DEVELOPMENT REVIEW BOARD REPORT

CASE NUMBER/ PROJECT NAME	59-DR-2005 Park Break Office		
LOCATION	14080 N. Northsight Boulevard		
REQUEST	Request approval of a site plan, elevations, and a landscape plan for a single story office building..		
OWNER	Park Break LLC 480-596-9000	ENGINEER	N/A
ARCHITECT/ DESIGNER	Mittelstaedt & Cooper Associates Ltd. 602-389-4230	APPLICANT/ COORDINATOR	Jan Mittelsaedt Mittelstaedt & Cooper Associates Ltd. 602-389-4230
BACKGROUND	<p>Zoning.</p> <p>The property is zoned Service Residential, Planned Community Development (S-R, PCD). Office uses are permitted in this district.</p> <p>Context.</p> <p>The property is located within the Northsight mixed-use project along the Loop 101. Specifically, the subject property is located on the west side of Northsight Boulevard, approximately 1,500 feet south of Raintree Drive. The specific address of the site is 14080 N. Northsight Boulevard. The site, currently undeveloped, is relatively flat and contains no vegetation. There are a variety of zoning districts that bound the property including office, industrial, and open space.</p> <p>Adjacent Uses:</p> <ul style="list-style-type: none">• North: Los Padres Bank bui

③ PARKING CANOPY SECTION

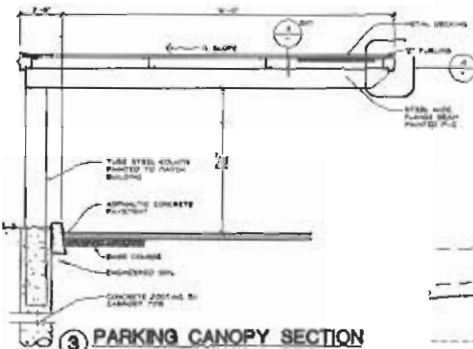
7. Dooley wall fencing shall not be allowed.
8. All walls shall match the architectural color, materials and finish of the building(s).
9. All metal surfaces on parking canopies shall be painted to match a color from the building palette.

- A. *A proportional share of handicapped spaces must be provided under the parking canopy, or the canopy must be designated employee only.*

SITE PLAN

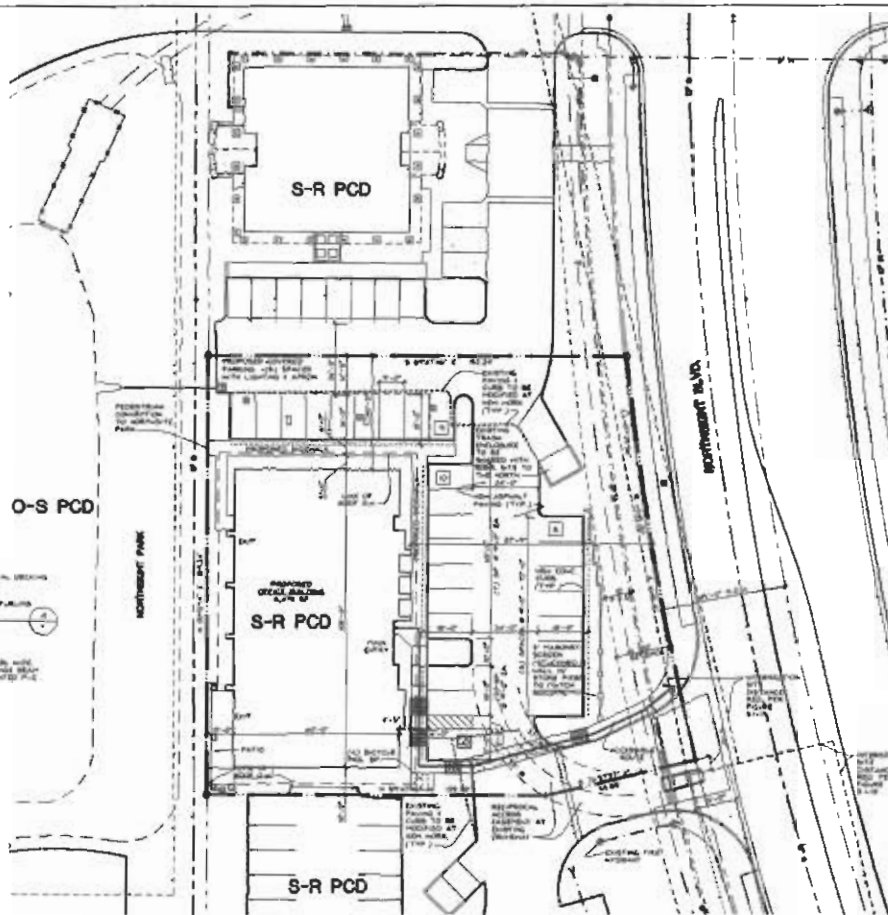
25. Due to a potential conflict with car backing up into entry drive, it is recommended that the plans be revised to show an elimination of a parking space in the southwest corner and adding a parking space at the location south of the existing refuse enclosure as an alternative.
